R22 SERVICE BULLETIN SB-115

SUBJECT: Air/Oil Separator Hose Spring

EFFECTIVITY: R22 Helicopters S/N 4783 thru 4801. Also helicopters retrofitted with air/oil separators.

FIGURE 1

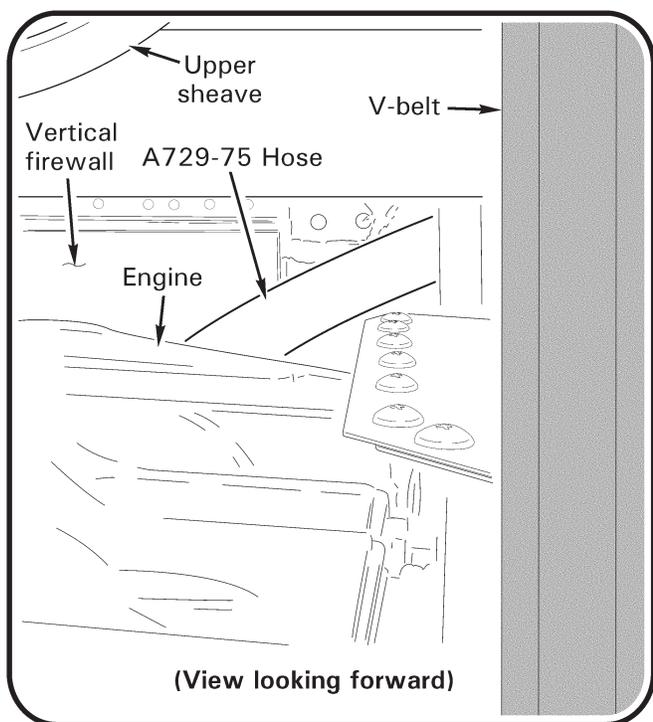
Refer to Figure 1. Looking forward over top of right-side of fan scroll inboard of v-belt and using a bright light, visually inspect A729-75 black rubber breather hose. If hose is kinked, remove and replace prior to further flight. (Note: Ends of hose are not visible from this perspective, but a kink, if present, will be apparent in exposed center portion. If in doubt, side panel(s) may be removed for better view.)

FIGURE 2

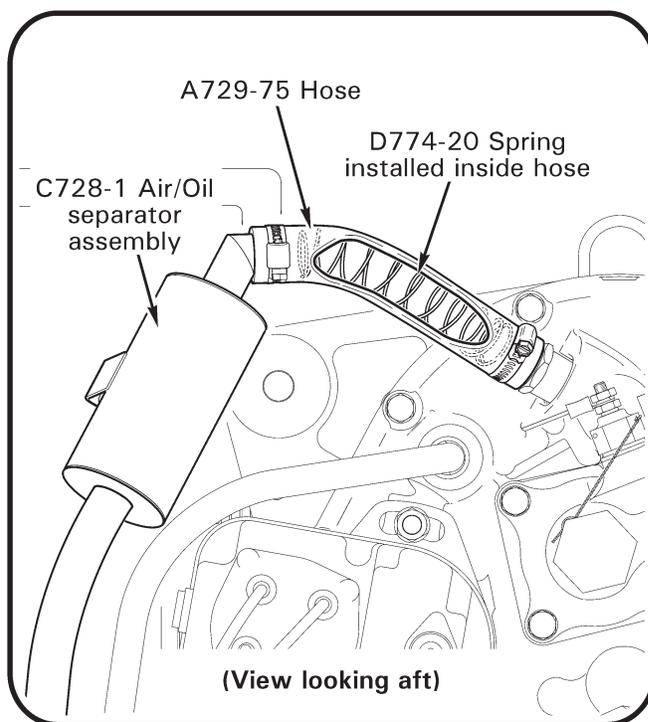
BACKGROUND: RHC has determined the A729-75 hose, installed between the engine and C728-1 air/oil separator assembly, may be susceptible to kinking. A kinked hose could cause the crankcase to vent through the separator drain back tube and result in loss of engine oil. Part A of this bulletin requires immediate inspection of breather hose to determine if hose is kinked. Part B requires installing a replacement hose and inserting a spring inside the hose to prevent kinking.

1. Refer to Figure 2. For each affected helicopter, order one D774-20 spring and one A729-75 crankcase breather hose from RHC Customer Service.
2. Remove engine RH cowling.
3. Remove screw securing air/oil separator's can-to-frame clamp.
4. Loosen B277-12 clamps and remove A729-75 hose; retain clamps and discard hose.

5. Install new A729-75 hose and insert new D774-20 spring inside hose; secure hose with retained clamps.
6. Install screw securing air/oil separator's can-to-frame clamp. Verify security.
7. Install engine RH cowling.
8. Make appropriate maintenance record entries.
